## **Smart Configurator for RX V2.9.1**

## Release Note

R20UT4487ES0291 Rev.2.91 Apr.13.21

Figure 2-1: New icons for "Generate Code" and "Generate Report" functions

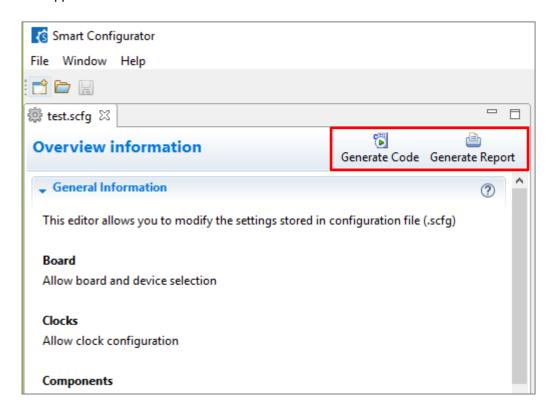
From Smart Configurator for RX V2.9.1, bigger toolbar icons for "Generate Code" and "Generate Report" functions are applied as below.

Figure 2-3: Root folder path for the generated source files

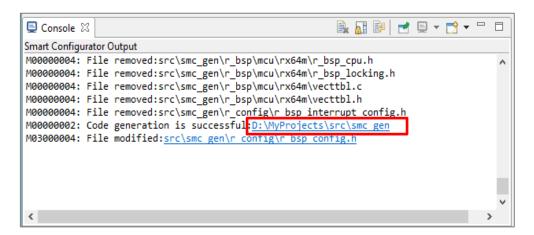
From Smart Configurator for RX V2.9.1, the root folder path for the generated source files has been outputted to console window after code generation, and user can open this folder directly by just clicking its hyperlink.

Figure 3-1: New Import Board Settings dialog for Board page

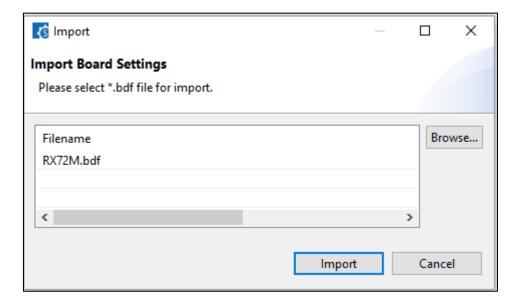
An Import Board settings dialog box has been added after clicking the "Import" button on Board page

Figure 3-2: New Import Pin Assignments dialog for Pins page

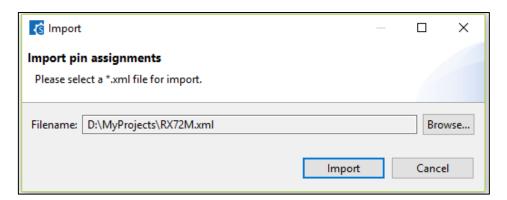
An Import Pin assignments dialog box has been added after clicking the "Import" button on Pins page

Figure 3-3: New Export Pin Assignments dialog for Pins page

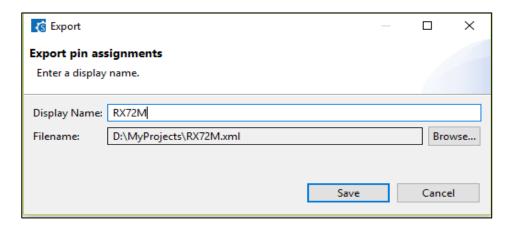
• An Export Pin assignments dialog box has been added after clicking the "Export" button on Pins page

Figure 5-1: Resource tree without any pin in FIT component GUI

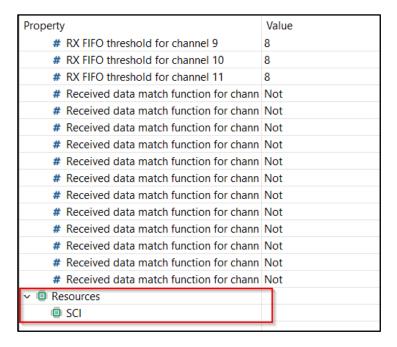
When configuring the FIT component, the resource tree is still visible even there is no pins under it, for such case it will be hidden from next release

Figure 5-3 Error is displayed on the hardware resource tree for pin assignment

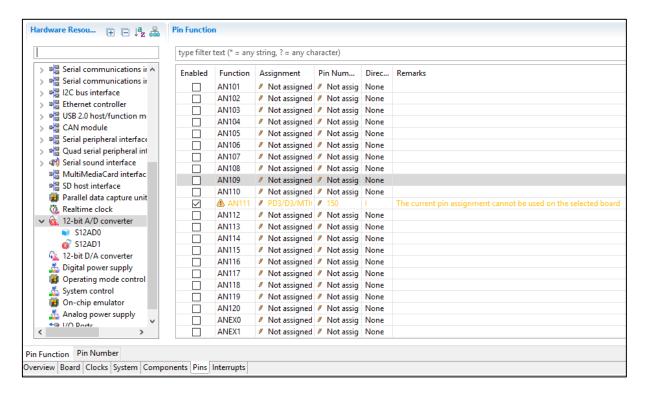
When performing pin assignment with selected board, if the pin assignment is not supported by selected board, by default a warning icon should be displayed besides the pin assignment and also on the corresponding hardware resource tree note, but an error icon is shown on the hardware resource tree node instead which is unexpected, this issue will be fixed from next release

Figure 6-1 "Address output pin setting" value should be disable

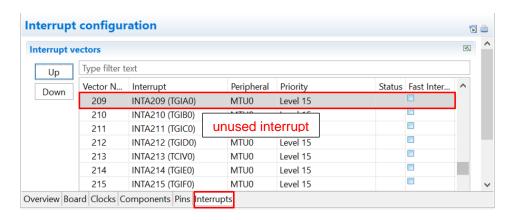
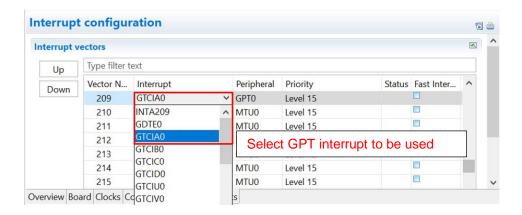
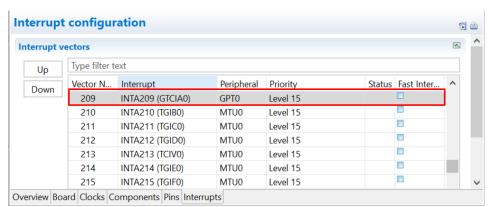
The GPT interrupts are not specified as the Software Configurable Interrupt in the initial state even after the GPT interrupts are configured by GPT component. To specify GPT interrupts as Software Configurable Interrupt source, release unused Software Configurable interrupt source on the Interrupt sheet and allocate GPT interrupts instead.

Figure 6-2 Ignore warnings when TXDn pin is disabled (Example with TXD0)

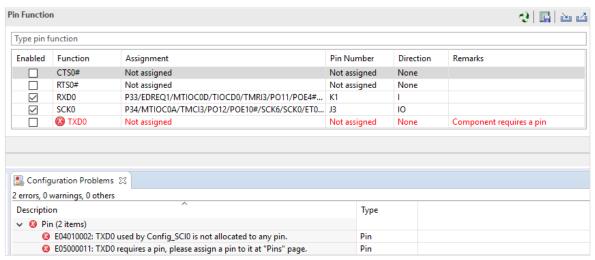
In SCI Clock Synchronous Mode using internal clock, if only reception is enabled in high communication speed, extra clocks are generated even though reception has been completed.

This is due to the delay in disabling RE to stop the clock after the desired number of data is received. To prevent this issue, select Transmission/Reception work mode when using Smart Configurator. Use "R\_<Configuration Name>\_Serial\_Send\_Receive" function instead of "R\_<Configuration Name>\_Serial\_Receive". The same number of data for tx\_num and rx\_num should be specified. Disable TXDn pin in Smart Configurator Pins page and send dummy data if transmission is not required. There will be warnings when TXDn pin is disabled. These warnings can be ignored as TXDn pin is not intended to be used originally.
